CITY PLAN COMMISSION**THURSDAY, FEBRUARY 15, 2024****FILE NUMBER:** S212-092R**SENIOR PLANNER:** Sharmila Shrestha**LOCATION:** between Prater Road and Haymarket Road, north of Lyndon B Johnson Freeway/Interstate Highway No. 20**DATE FILED:** January 17, 2024**ZONING:** PD 1076**PD LINK:** [Article 1076.pdf \(dallascityhall.com\)](https://www.dallascityhall.com/Article/1076.pdf)**CITY COUNCIL DISTRICT:** 8**SIZE OF REQUEST:** 34.203-acres**APPLICANT/OWNER:** Liberty Banker Life Insurance Co.

REQUEST: An application to create a 161-lot single family subdivision with lots ranging in size from 5,248 square feet to 10,294 square feet and 7 common areas from a 34.203-acre tract of land in City Block 8779 on property located between Prater Road and Haymarket Road, north of Lyndon B Johnson Freeway/Interstate Highway No. 20.

STAFF RECOMMENDATION: The request complies with the requirements of PD 1076; therefore, staff recommends approval of the request subject to compliance with the following conditions:

City Plan Commission Date: 2/15/2024 20(h) **S212-092R**

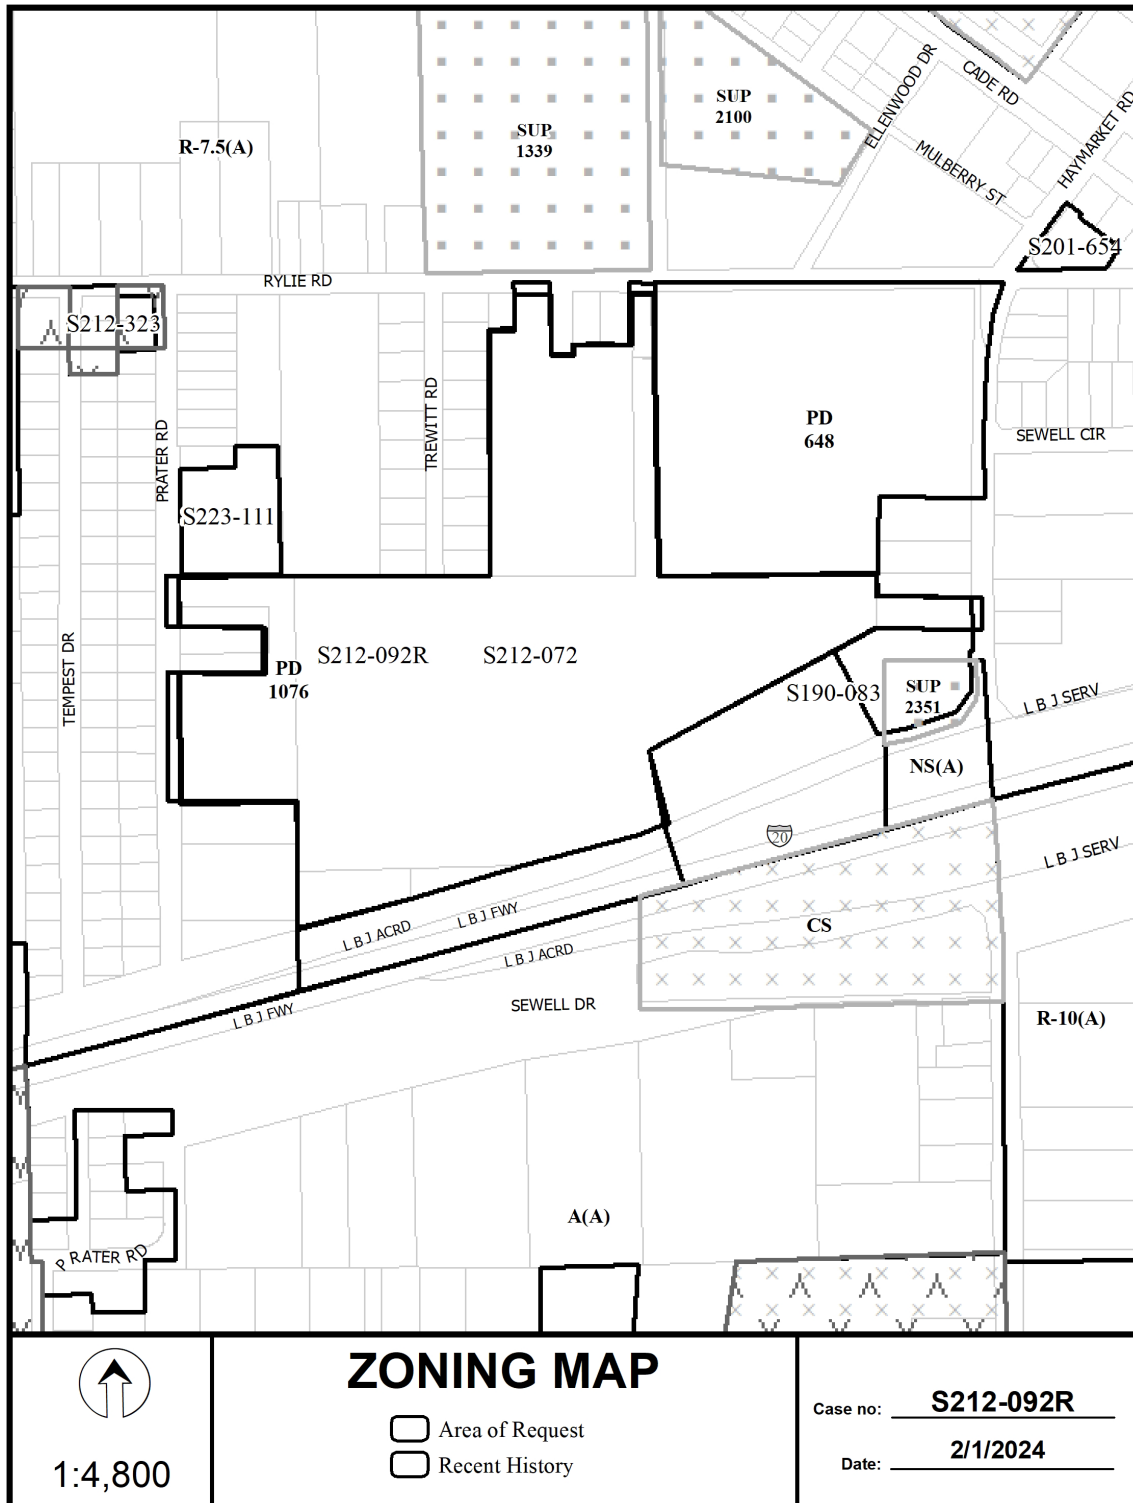
15. On the final plat, dedicate 30 feet of right-of-way (via fee simple) from the established center line of Haymarket Road and Rylie Road. *Section 51A 8.602(c)*

16. On the final plat, dedicate 28 feet of right-of-way (via fee simple or street easement) from the established centerline of Prater Street. *Sections 51A-8.602(c), 51A-8.604(c) and 51A-8.611(c).*

17. On the final plat, dedicate 56 feet of right-of-way (via fee simple) for all internal streets. *Section 51A 8.602(c)*
18. On the final plat, dedicate a minimum 5-foot by 5-foot corner clip (via fee simple or street easement) at all internal street intersections. Section 51A 8.602(d)(1)

31. Additional design information is required for assessment. Site plan must be submitted showing proposed development, building finished floor elevation, development, existing mains – including downstream manhole, and proposed water and wastewater service locations. Submit water/wastewater engineering plans to 320 E. Jefferson Blvd., Room 200, Attention: Water and Wastewater Engineering.

34. Existing and any proposed Water and Wastewater Easements must be shown and/or increased to conform to current design standards. **Notice:** Minimum DWU easement size 20' for one utility and 25' for both water and sewer. Larger diameter or deeper mains may require additional width.

35. On the final plat, change “Don Belknap Dr” to “Don Belknap Drive (FKA Tufts Road)”.
36. On the final plat, change “Lyndon B Johnson Freeway/Interstate 20” to “Lyndon B. Johnson Freeway/Interstate Highway No. 20”.
37. On the final plat, identify the property as City Blocks F/8779 through H/8779, City Block J/8779, and K/8779.
